## TECHNICAL NOTE

File Ref: PZ/JB/P21-2369/01TN - Theberton Hall

Subject: Theberton Hall – Deadline 6 Noise

# CONSTRUCTION AND OPERATIONAL NOISE ASSESSMENT THEBERTON HALL

**Figure 5.2: Measurement Location** Excerpt from Book 6, Volume 6, Chapter 4, Figure 4.2

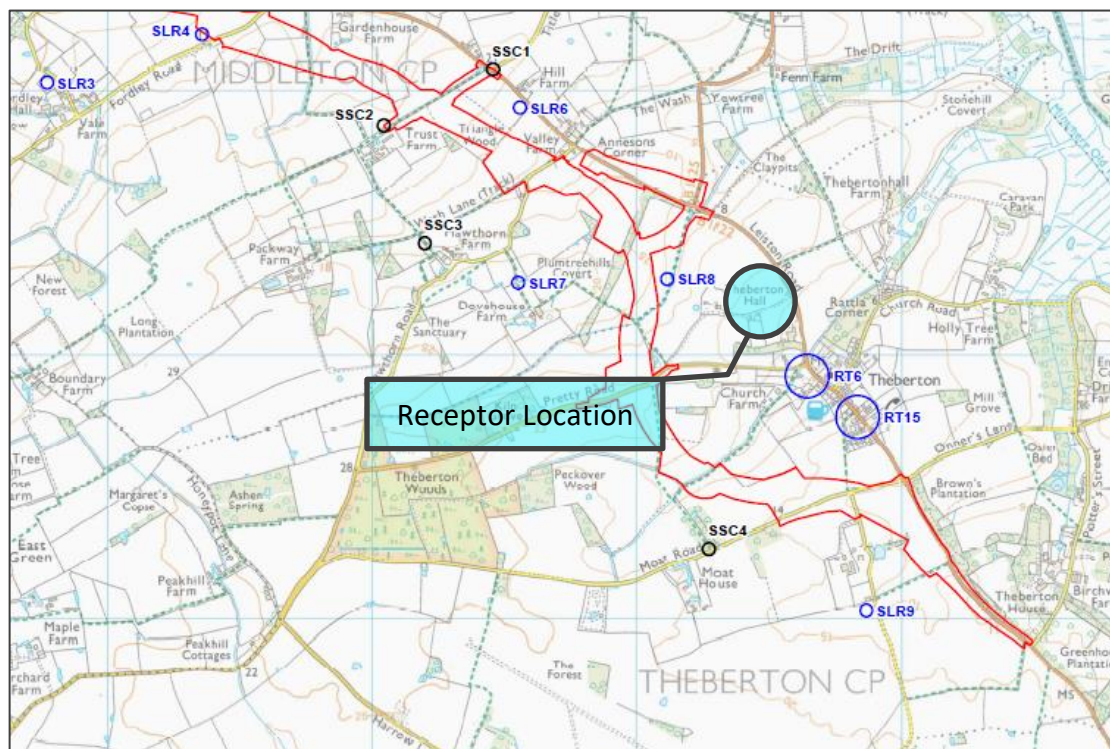
- 5.4 The most representative monitor location in the EDF ES for the Theberton Hall NSR would be SLR 8, which was stated to be a typical measured daytime level of 40-41 dB  $L_{Aeq,T}$ . (Table 4.13, Book 6, Volume 6, Chapter 4). A detailed analysis of the measured sound levels was included within Book 6, ES Volume 2, Chapter 11, the Noise and Vibration Baseline Report.

- 5.5 Within the submitted document, the baseline sound levels were largely similar to those from the Create baseline sound monitoring for the daytime ambient sound level, although there was a 4 dB excess over those measured by Create.

- 5.6 Presumably the considerable difference was due to the reliance on the lack of measurement data by EDF, whose calculations were reliant on two individual 30minute measurements during the day and no measurements during the night time (Page 116 – Book 6, Volume 2, Chapter 11, Appendix 11A).
